METROPOLITAN GOVERNMENT OF NASHVILLE AND DAVIDSON COUNTY

STAFF RECOMMENDATION
919 McFerrin Avenue
December 18, 2013

Application: New construction—infill and outbuilding
District: Greenwood Neighborhood Conservation Zoning Overlay
Council District: 06
Map and Parcel Number: 08204037800
Applicant: William Gant, owner
Project Lead: Melissa Baldock, melissa.baldock@nashville.gov

919 McFerrin Ave Site Plan

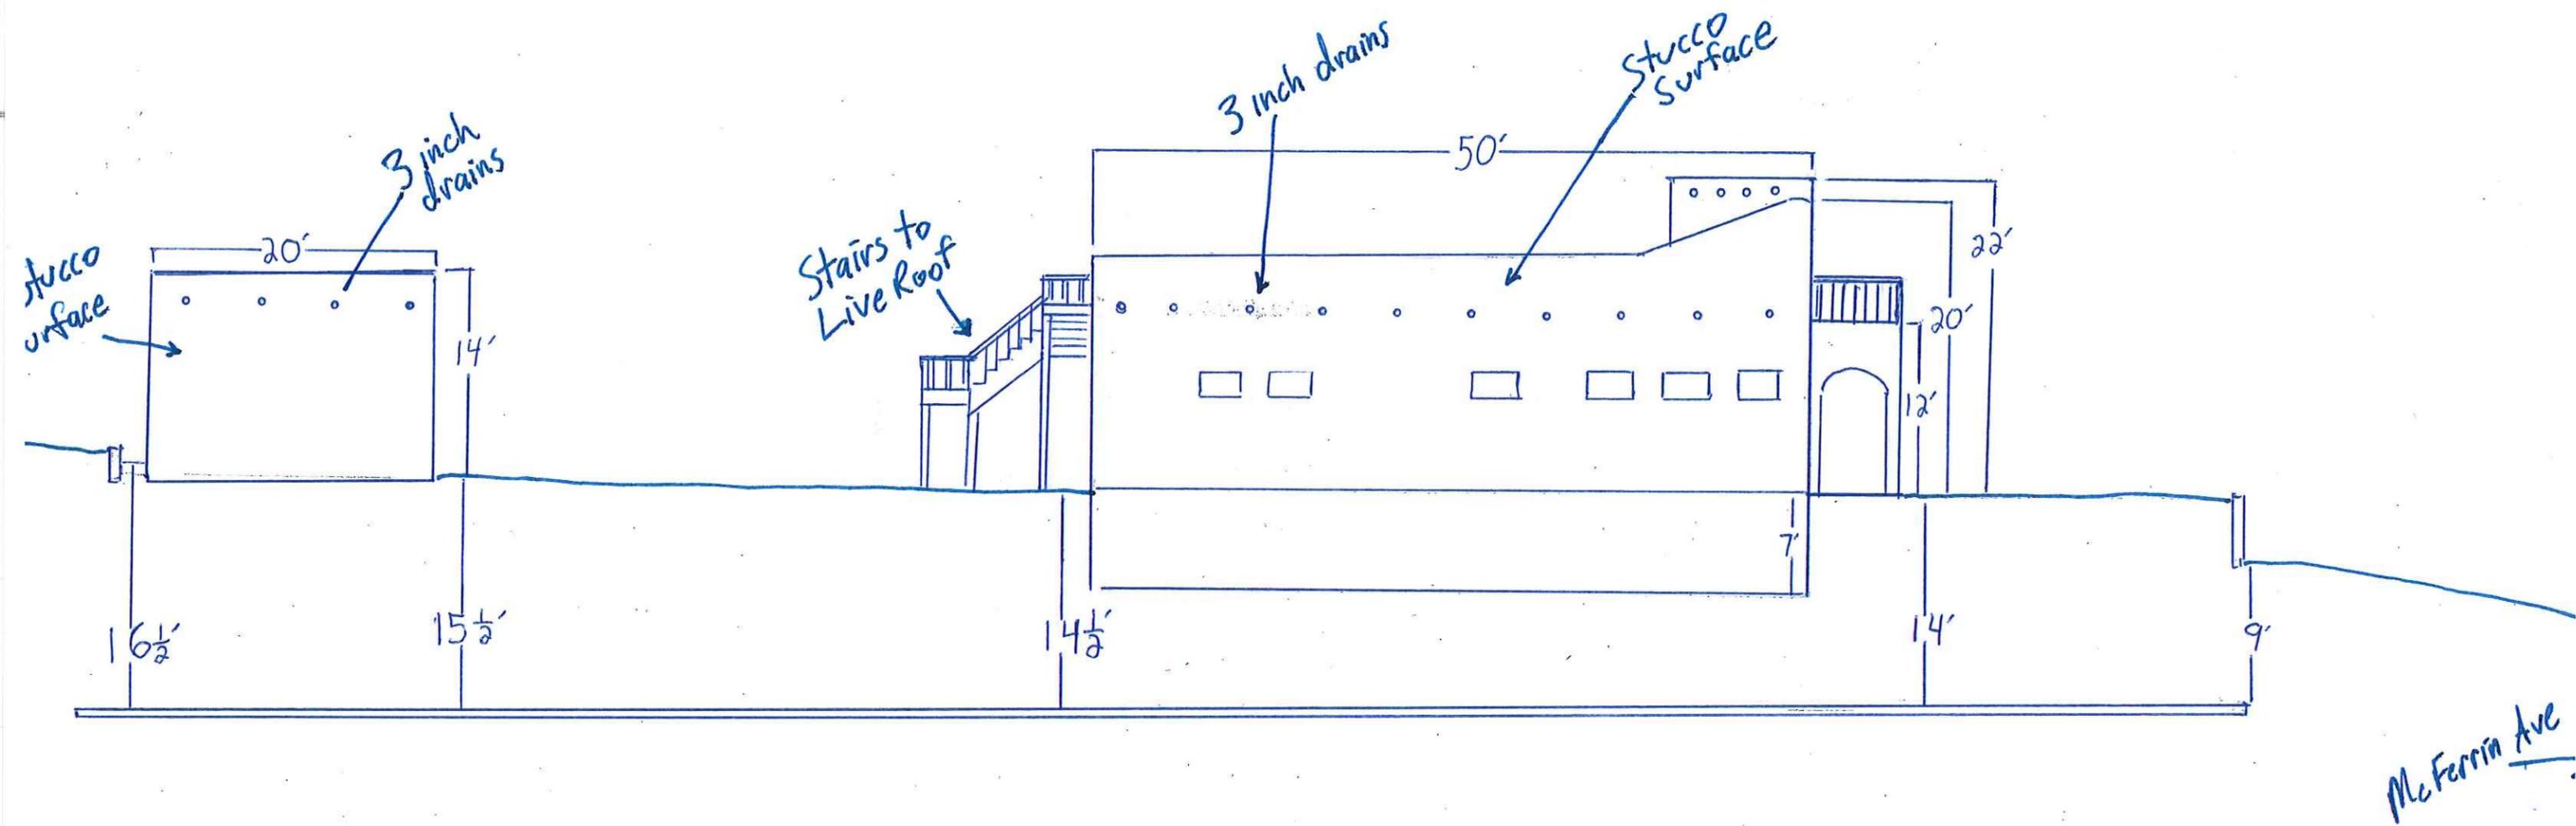
Setback & Rhythm of Spacing: The proposed infill meets all base zoning setbacks. It will be five feet (5') from the north/left property line and seven feet (7') from the south/right property line. The front porch will be twenty-four feet (24') from the front property line; the front wall of the house will be thirty feet (30') from the front property line. Staff's examination of the setbacks on the two neighboring houses shows that their front porches are between thirty and thirty-three feet (30' – 33') from the front property line. Staff typically recommends that the front setback for the front porch of the infill lines up with the neighboring houses' front porches, or be an average of the two. Staff therefore finds that the proposed front setback does not meet Section II.B.1.c. of the *Greenwood Neighborhood Conservation Zoning Overlay: Handbook and Design Guidelines*.

Appurtenances & Utilities: The applicant plans to retain an existing driveway on the south side of the property. The location of the HVAC and other utilities was not noted. Staff recommends that the HVAC be located on the rear façade, or on a side façade beyond the midpoint of the house.

Outbuildings: The project includes a twenty foot by thirty foot (20' X 30') accessory structure that is utilitarian in design, which is appropriate, particularly since the structure will only be minimally visible from the street. The accessory structure will be accessed via an existing driveway, and will be located at the rear of the property. The accessory structure meets all base zoning setbacks; it is three feet (3') from the rear property line, five feet (5') from the north/left side property line, and fifteen feet (15') from the south/right property line. The garage doors will face the street, and there will be two separate garage doors and bays, which is appropriate. The outbuilding will have a flat roof and will be fourteen feet (14') tall. The materials will be stucco with a rubber roof that will not be visible. The materials for the doors were not indicated, and staff asks to approve the vehicular and pedestrian doors prior to purchase and installation. Staff finds

Elevation

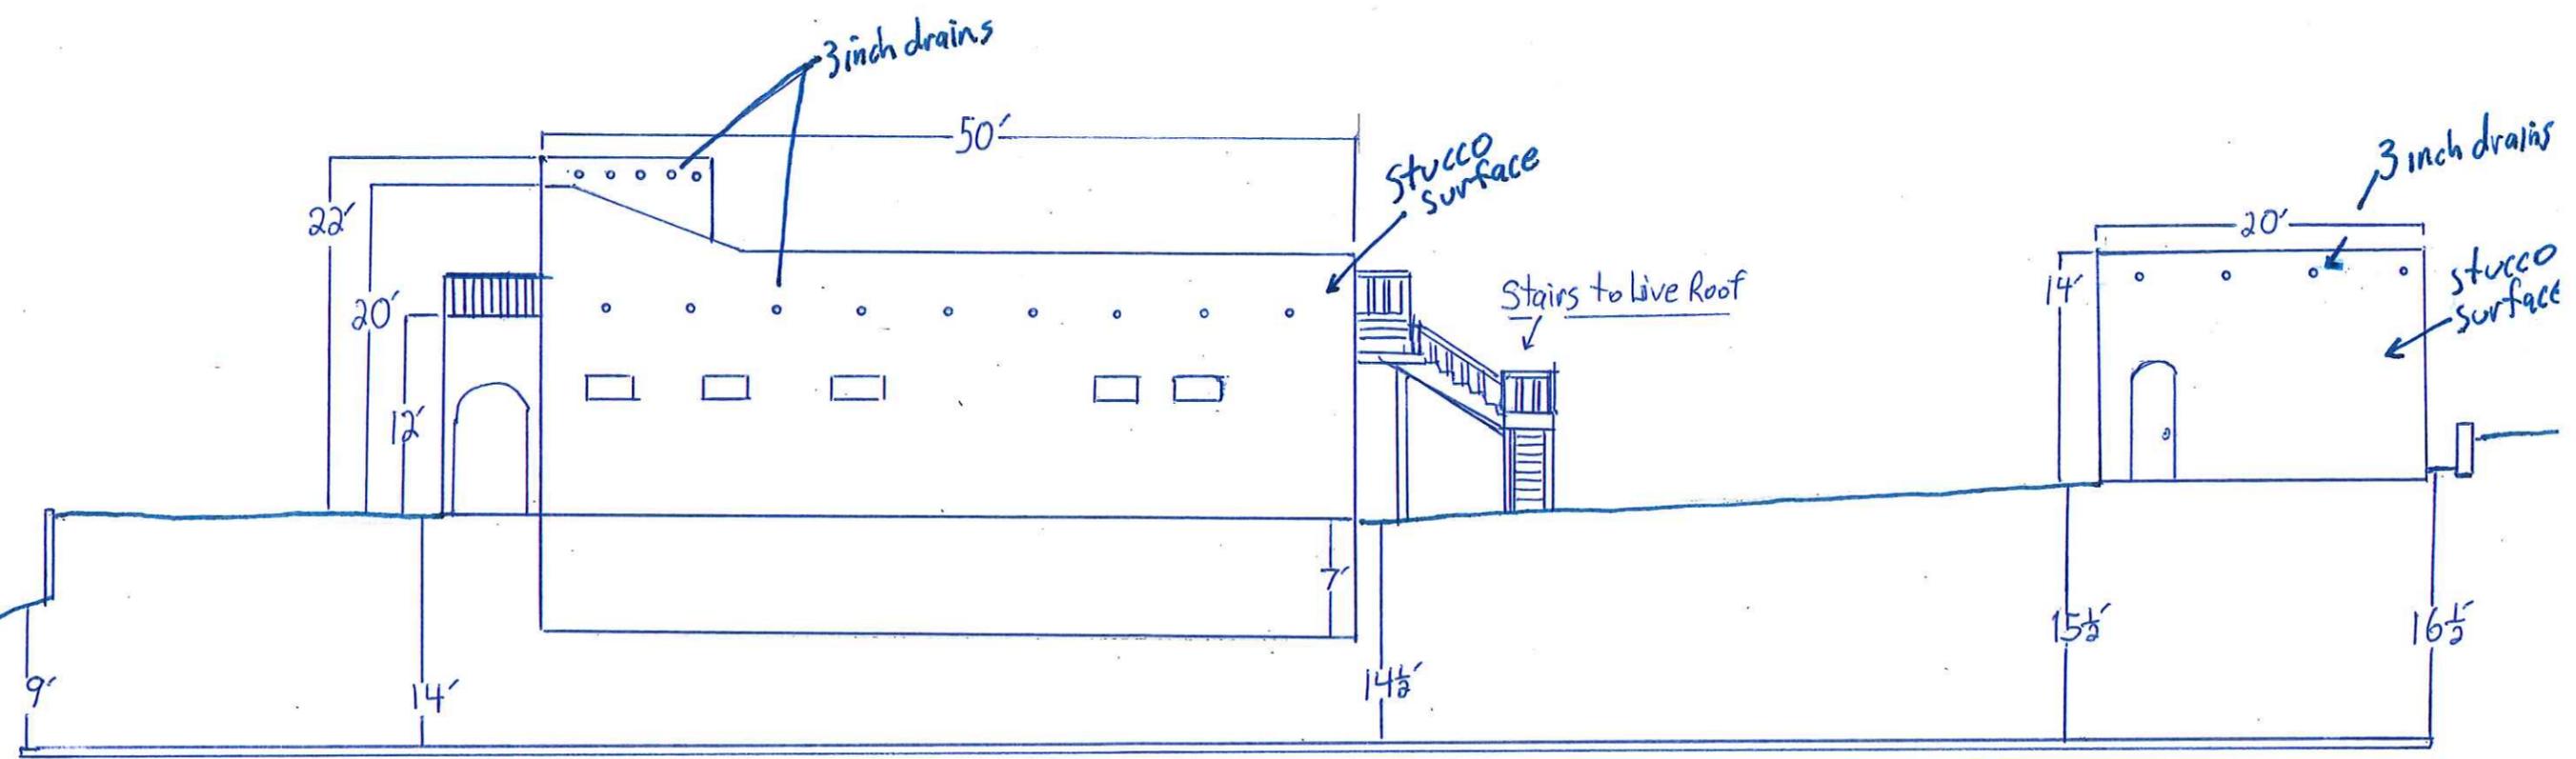
The house is designed to be one story tall and has a ridge height of twenty-two feet (22') above grade. Staff finds that this matches the historic context, where houses range between fifteen feet and thirty feet (15'-30') tall. The house's eave height at the front is fifteen feet (15'), which is taller than what is typically seen on a one-story structure. In

addition, the house lacks a foundation line, so there is no foundation height to measure. This is not typical of historic houses in the Greenwood Neighborhood, which have a change in material from the foundation to the cladding above. The porch height is twelve feet (12'). Because the porch has a flat roof, this is taller than typical front porches in the Greenwood neighborhood.

While the overall height and width of the proposed infill matches the context, the eave and porch height, and the lack of a defined foundation line does not match the historic context. Staff therefore finds that the infill does not meet sections II.B.1.a. and b. of the *Greenwood Neighborhood Conservation Zoning Overlay: Handbook and Design Guidelines*.

Materials: The primary material for the infill is stucco. Staff did not identify any historic structure in the Greenwood conservation overlay with stucco as its primary material. The vast majority of the historic structures in the neighborhood have brick or lap siding as their primary material. The roof material is to be coated steel tile, which is not found in the district. Shingle or standing seam metal roofs are the predominant roof material for historic houses in Greenwood. The front porch roof railing will be wrought iron. The materials for the windows and doors and the rear exterior stairs were not specified. Because the stucco facade and metal roof material are not appropriate for the Greenwood neighborhood, staff finds that the project's materials do not meet Section II.B.1.d. of the *Greenwood Neighborhood Conservation Zoning Overlay: Handbook and Design Guidelines*.

Roof form: The applicant is proposing that the front portion of the roof be a side gable with a slope of 12/12. No eaves are shown on the drawings. The gable portion of the roof only extends ten feet (10') back from the front wall of the house. Behind the gable, the house has a flat roof form in order to allow for a live (or green) roof. In order for a roof form like this to be appropriate, the gable will need to extend further back on the house, eave overhangs need to be incorporated, and the eave height needs to be lowered.

The front façade includes a central wall dormer. The Commission in the past has not allowed wall dormers, particularly on front facades, and has required that the wall of the

dormer be set back two feet (2') from the wall below. The dormer therefore does not meet the design guidelines.

The front porch has a flat roof with a second story balcony accessed via a doorway in the dormer. Staff finds that this roof form does not match the historic context, where porch roofs typically have a gable form or a low slope shed form. Front porch balconies are not seen in the district, and do not meet the design guidelines.

Proportion and Rhythm of Openings: The window openings on the front and on the front portion of the side facades have arched openings. This does not match the proportion of window openings in the district, where most historic windows are rectangular and are at least twice as tall as they are wide. The side facades contain windows that are horizontal in nature and are three feet (3') wide and two feet (2') tall. Staff finds that these windows also do not meet the proportion of window openings because they are not twice as tall as they are wide. Staff finds the project's proportion and rhythm of openings do not meet Section II.B.1.g. of the *Greenwood Neighborhood Conservation Zoning Overlay: Handbook and Design Guidelines*.

919 McFerrin $\frac{3}{16} = 1'$ Elevations

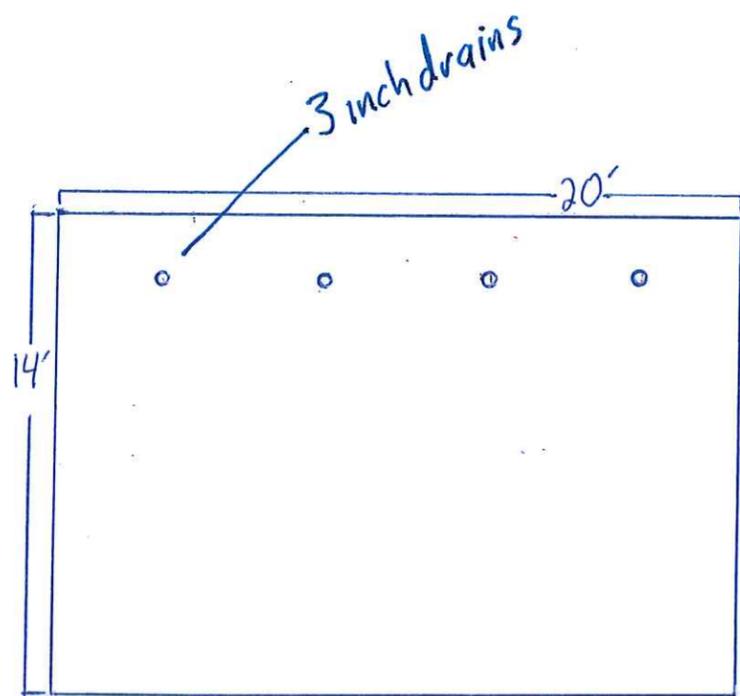
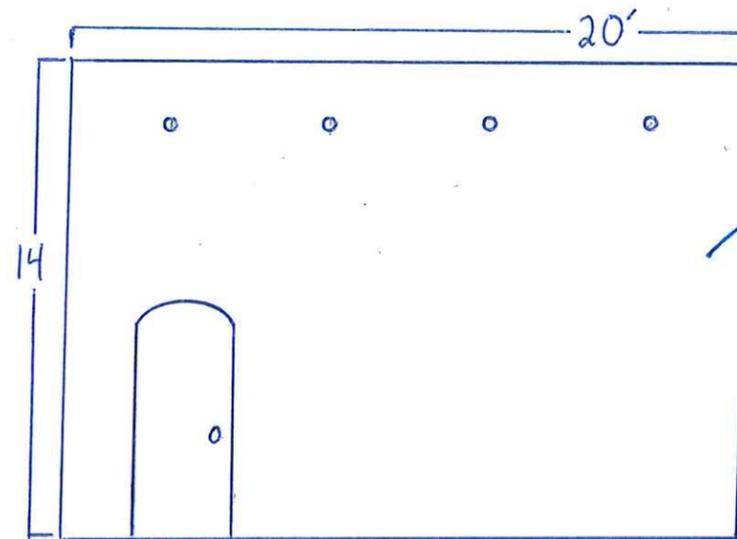
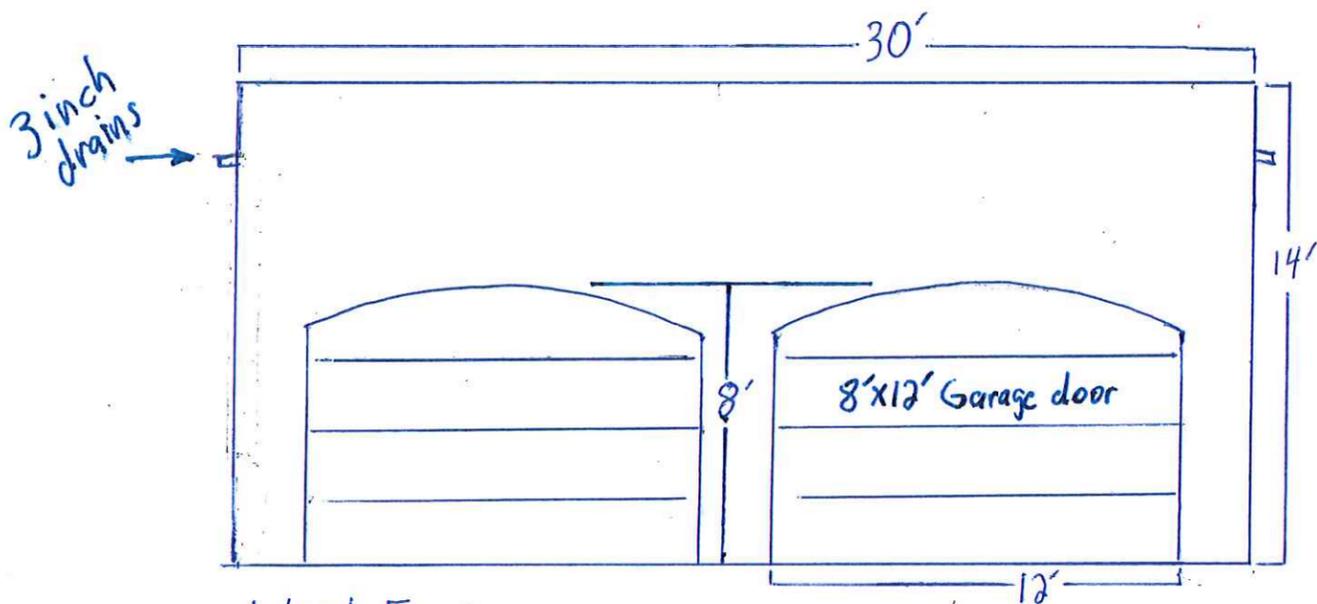
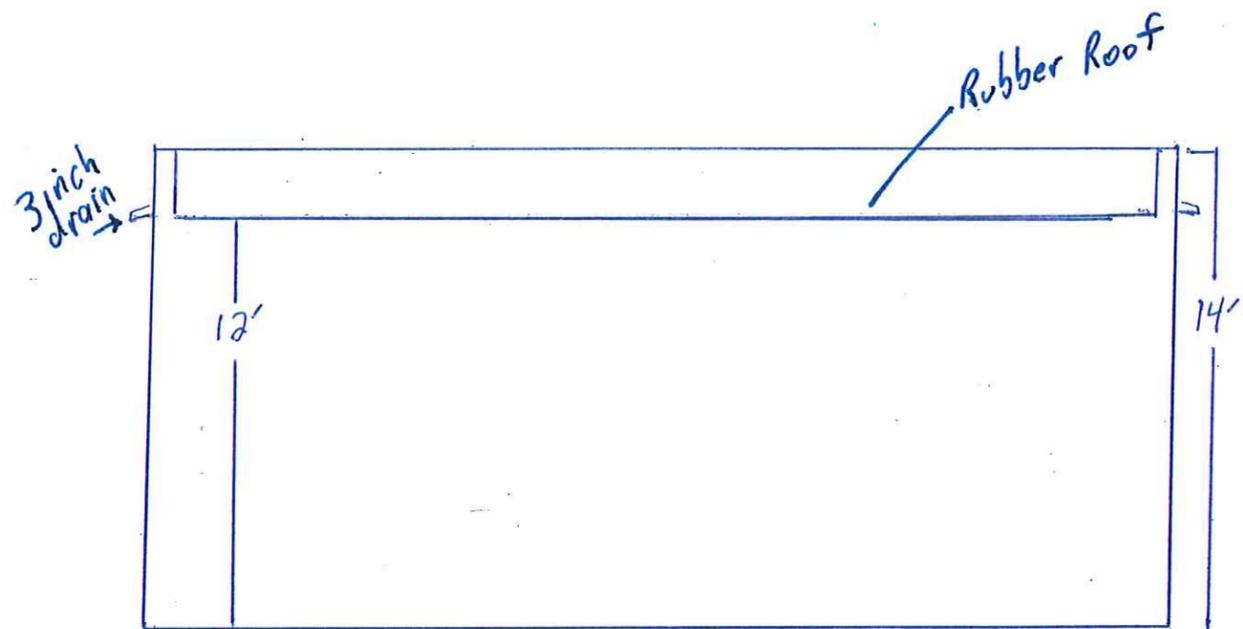
that the garage's height, scale, materials, orientation, and roof form are appropriate for an outbuilding. With the staff's approval of the doors, staff finds that the outbuilding meets section II.B.1.h of the *Greenwood Neighborhood Conservation Zoning Overlay: Handbook and Design Guidelines*.

With the condition that staff approve the door selections prior to purchase and installation, staff recommends approval of the outbuilding, finding that it meets Section II.B.1.h. of the *Greenwood Neighborhood Conservation Zoning Overlay: Handbook and Design Guidelines*.
